Reference: Environmental Resource Permit Application
3KS Family, LLLP - Crystal River Borrow Pit
Application/Petition No.: 912905
Citrus County, Florida

Response To Request for Additional Information, June 27, 2025
3KS Family, LLLP – Crystal River Borrow Pit
Application No. 912905

BORING LOCATION PLAN

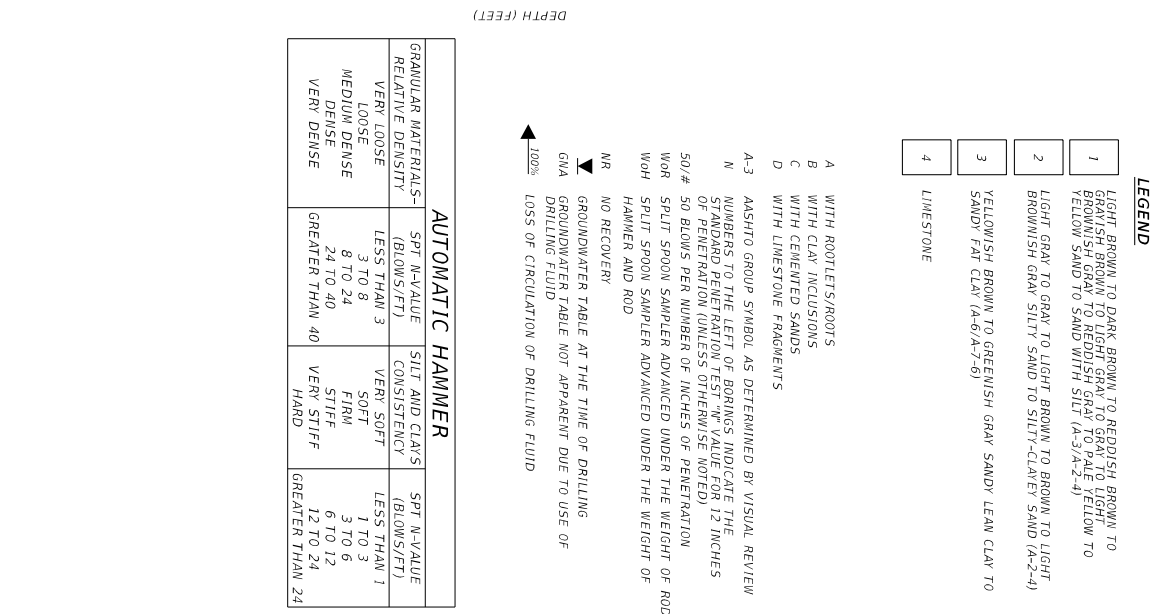
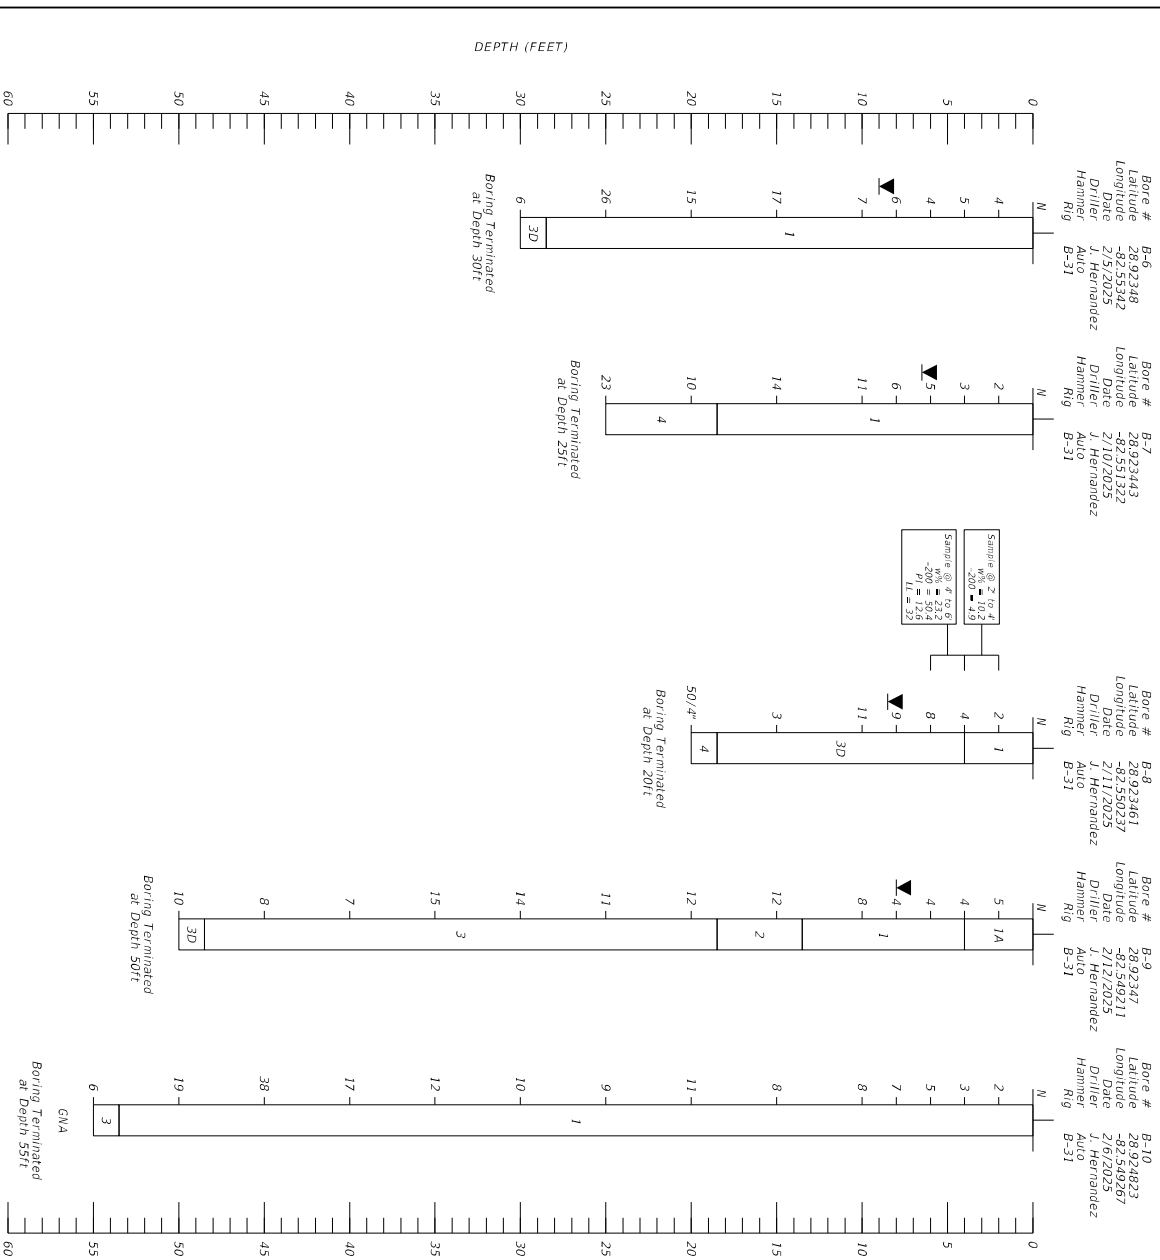
1. The submitted borings within the footprint of the proposed pond do not extend below the proposed pond bottom. It appears that additional borings are present on the submitted boring map however that information is not present in the provided boring logs. Please revise accordingly or provide borings that extend at least 2 feet below the proposed pond bottom. These borings will be used to verify that the depth of the pond shall not be excavated within two feet of underlying limestone. [Section 5.4.1, ERP Applicant's Handbook Vol. II (A.H.V.II)]

Response: Attached please find the March 3, 2025, geotechnical report prepared by TestLab, Inc., for Superior Construction. Also attached is a separate sheet showing the boring locations and boring elevations. The depths of the borings varied, but most went deeper than the proposed excavation. The shallowest observation of limestone was at approximately -6 feet elevation at B-16. The top of the limestone as found at approximately -8 feet elevation at three other locations, and then progressively deeper at the others (or not encountered). As noted in the submittal package, neither the clayey strata which is generally between the sand and the limestone, nor the limestone have any material value. Excavation will cease the moment either one is encountered.
